MAINE YANKEE ATOMIC POWER STATION

AMENDMENT TO FACILITY OPERATING LICENSE

Amendment No. 144

ATTACHMENT TO LICENSE AMENDMENT NO. 144

Figure  
 1.1-1

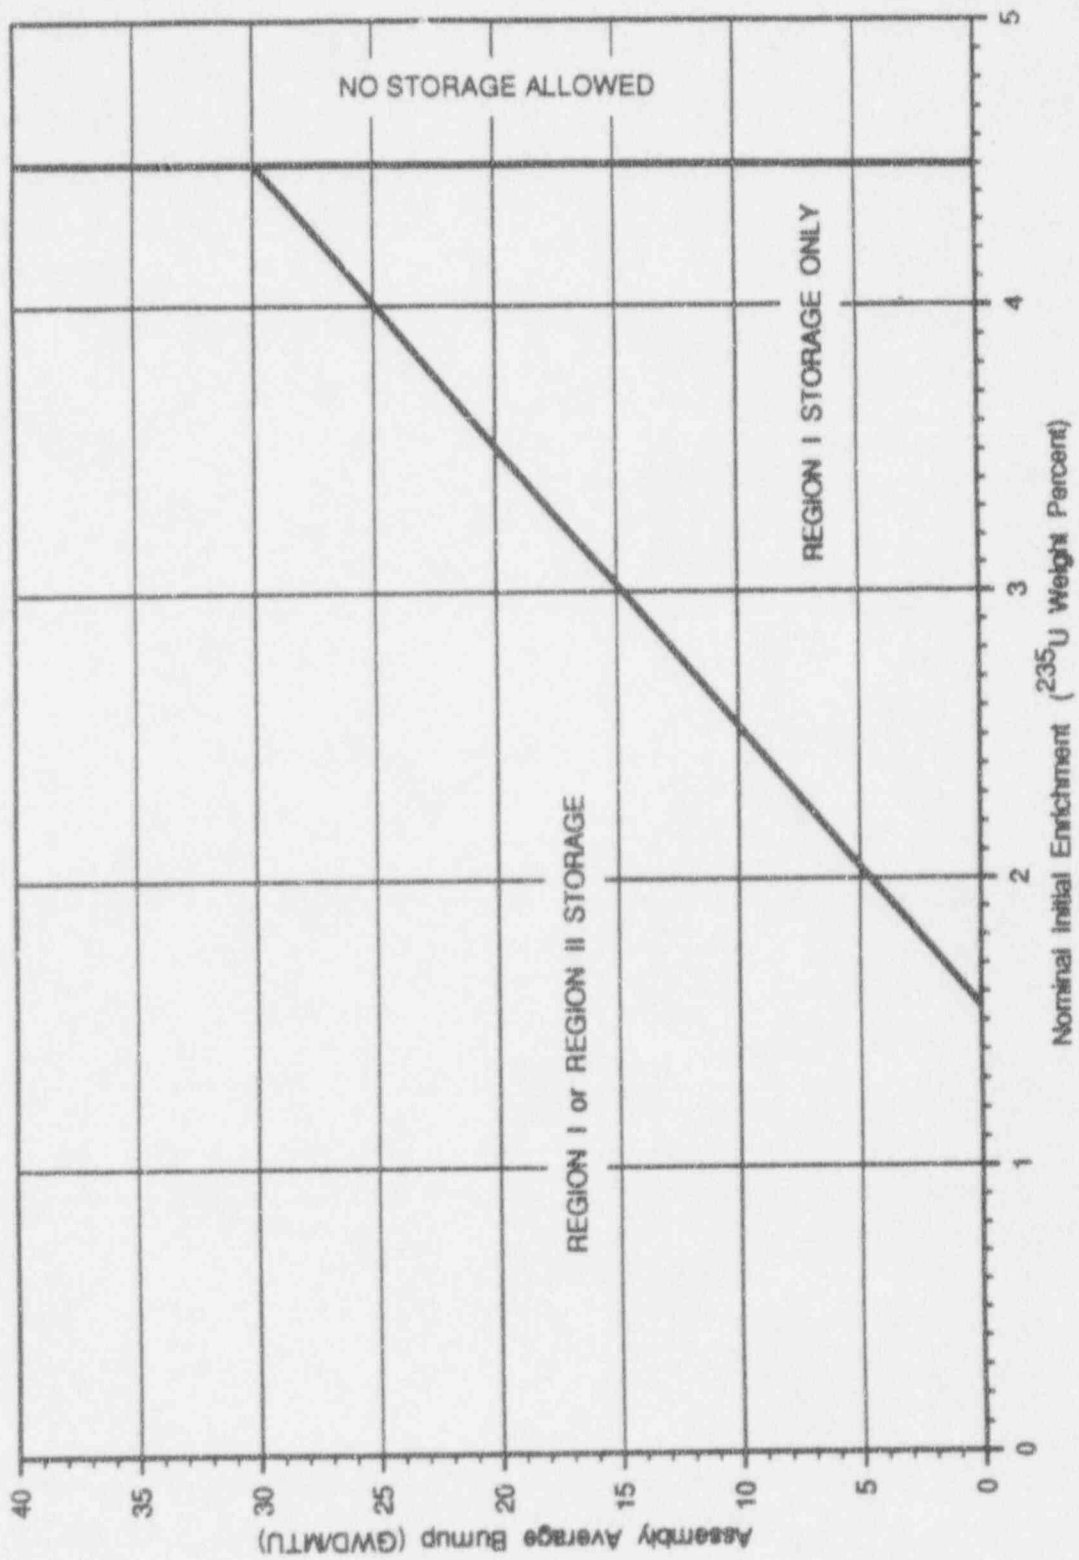
- D. Spent fuel shipping casks shall not be lifted over the spent fuel storage pool.
- E. No more than 2019 standard fuel assemblies shall be stored in either Region I or Region II of the spent fuel pool in accordance with the limitations of Figure 1.1-1. Unirradiated fuel assemblies shall be stored in either the New Fuel Storage Area or Region I of the spent fuel pool. Consolidated fuel shall be stored in Region II only.
